Docket Item # 6 & 7
BAR CASE # 2010-0150 & 0151

BAR Meeting
July 7, 2010

ISSUE: Permit to Demolish/Encapsulate & Addition/Alterations

LOCATION: 701 Chetworth Place

Figure 1. Proposed Plat

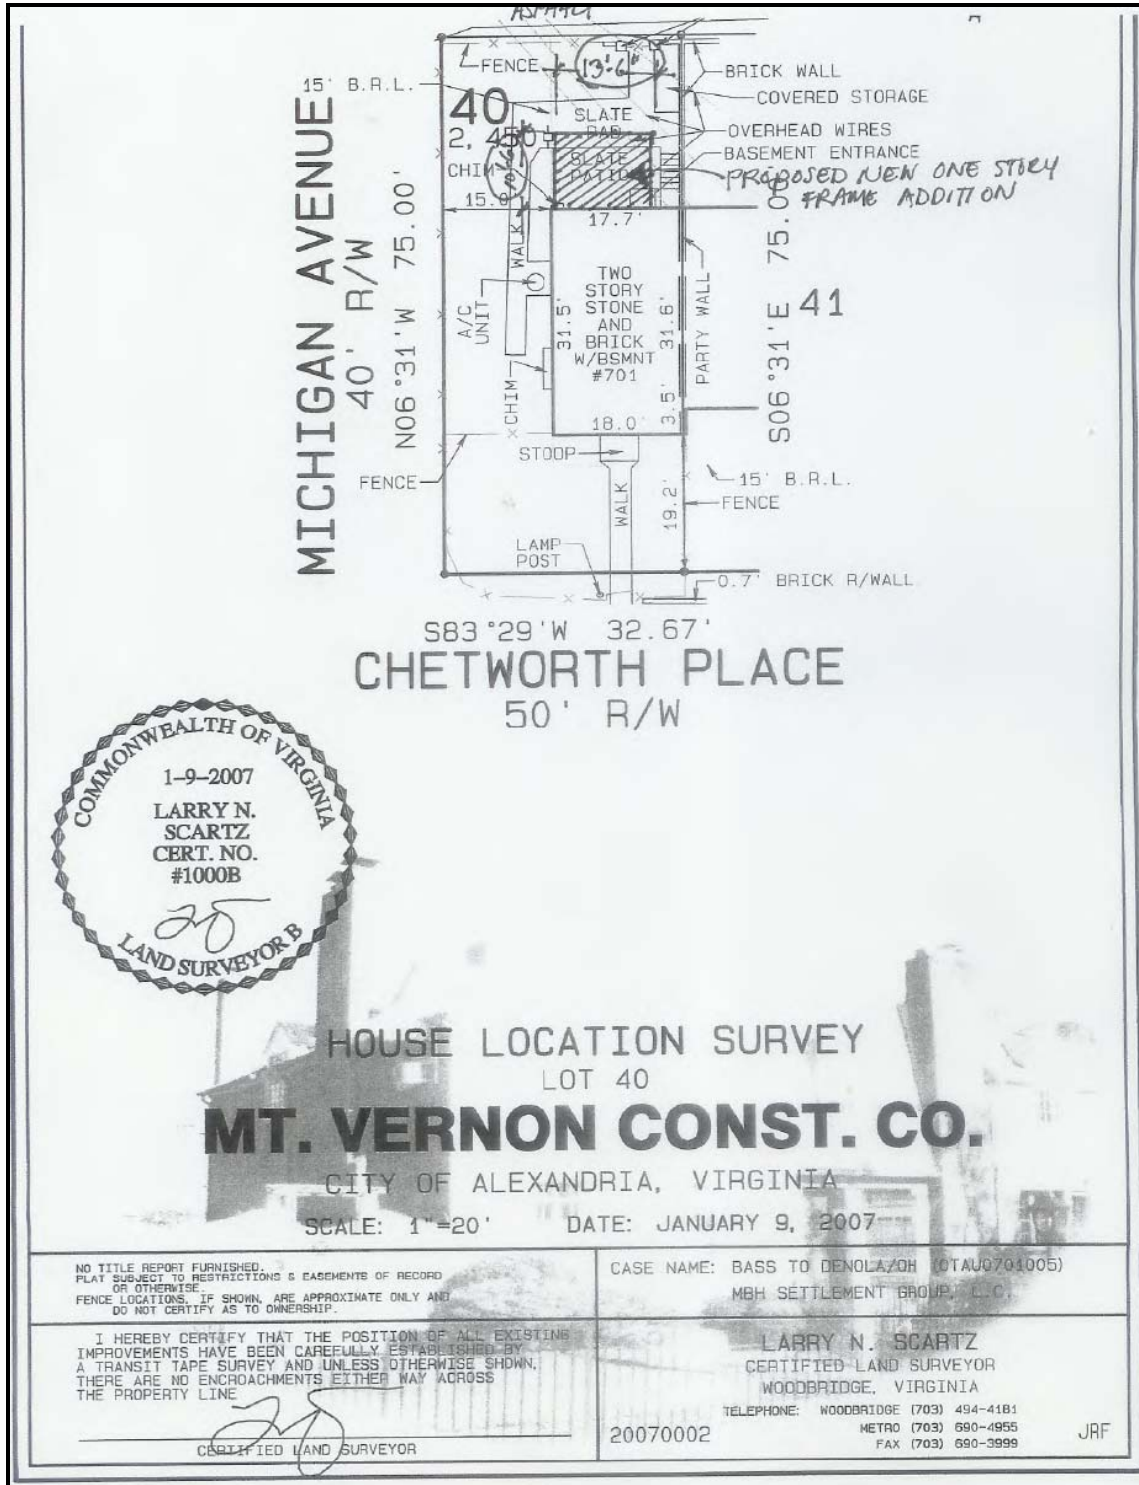
The proposed addition complies with Zoning Ordinance Requirements.

Figure 3. Proposed North & West Elevation

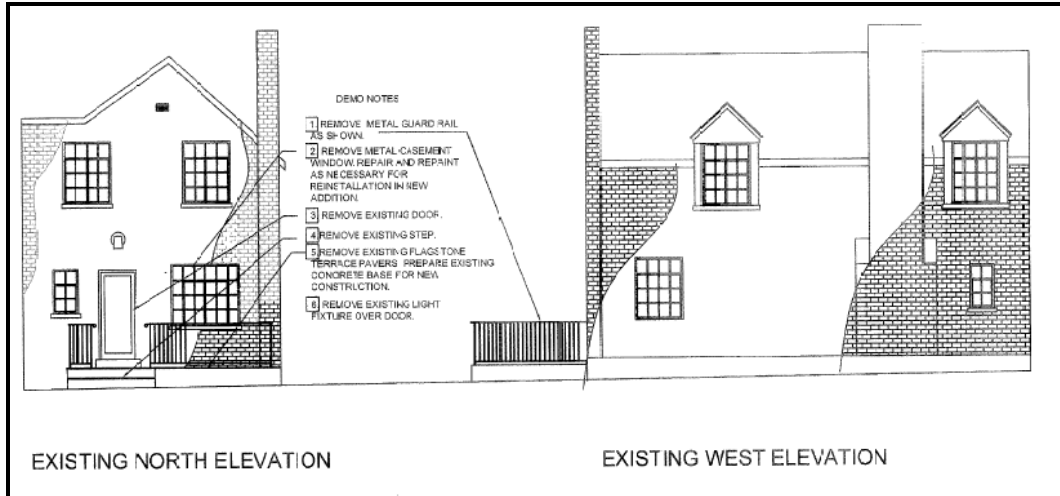
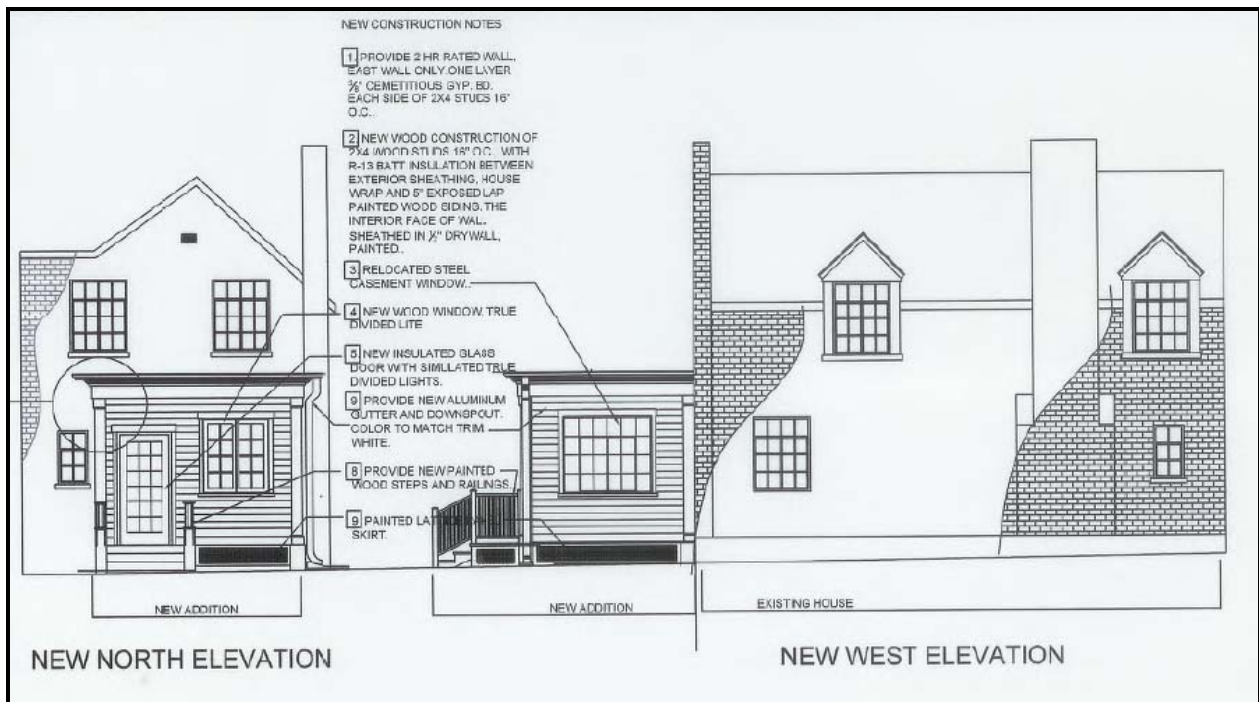
- Encapsulating 13' 6" from the western most corner of the rear wall of the first story. (133 sq. ft.)

- Constructing a new one-story, wood frame flat roof addition off the rear of 701 Chetworth Place. The proposed addition will measure 13' 6" wide and extend 10' 6" from the main block. The addition will be finished with 5" reveal clapboard wood siding. The new rear (north) elevation will consist of a new Rogue Valley wood, simulated divided, fifteen light, double insulated, French door and a new MW Windows wood, simulated divided, double insulated, double casement window with eight lights in each window and a 7/8" muntin profile. The applicant is proposing new wood steps and railing that will extend from the rear wall of the new construction and be painted to match the wood trim on the house. On the west elevation of the new addition the applicant is proposing to restore and reuse the metal casement window that is on the existing rear elevation. Details of the addition included a new bronze metal light fixture to be mounted to right of the door and a new aluminum downspout and gutter painted white to match the trim.

Staff has no objection to the proposed encapsulation, and believes that none of the criteria for demolition/encapsulation are met and that the Permit to Demolish/Encapsulate should be granted. Furthermore, Staff would like to commend the applicant for the restoration and reuse of existing historic fabric.
